2017/1151	Gtr 15 Am. 5	MR2	ECE-TRANS-WP29-GRPE-2019-05e
‘ Category of propulsion energy storage system ’ means (i) a fuel storage system, or (ii) a rechargeable electric energy storage system, or (iii) a rechargeable mechanical energy storage system.	‘Category of propulsion energy storage system’ means (i) a fuel storage system, or (ii) a rechargeable electric energy storage system, or (iii) a rechargeable mechanical energy storage system.	‘Category of propulsion energy storage system’ means (i) a fuel storage system, or (ii) a rechargeable electric energy storage system, or (iii) a rechargeable mechanical energy storage system.	
‘ Category of propulsion energy converter ’ means (i) an internal combustion engine, or (ii) an electric machine, or (iii) a fuel cell.	‘Category of propulsion energy converter’ means (i) an internal combustion engine, or (ii) an electric machine, or (iii) a fuel cell.	‘Category of propulsion energy converter’ means (i) an internal combustion engine, or (ii) an electric machine, or (iii) a fuel cell.

Starting point for further discussion:

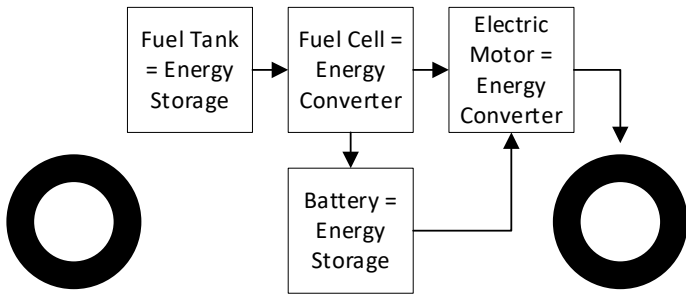
'Peripheral devices' means any energy consuming, converting, storing or supplying devices, ~~where the energy is not primarily~~ which do not directly or indirectly **apply torque to the drivetrain** ~~used for the purpose of vehicle propulsion, or other parts, systems and control units,~~ but which are essential to the operation of the powertrain and are therefore considered to be part of the powertrain.

'Propulsion energy converter' means an energy converter of the powertrain, whose output energy is ~~used~~ **applies torque** directly or indirectly **to the drivetrain** for the purpose of vehicle propulsion.

'Propulsion energy converter' means an energy converter of the powertrain, whose output energy is used by another energy converter for the purpose of vehicle propulsion or which **applies torque** directly ~~or indirectly~~ **to the drivetrain** for the purpose of vehicle propulsion.
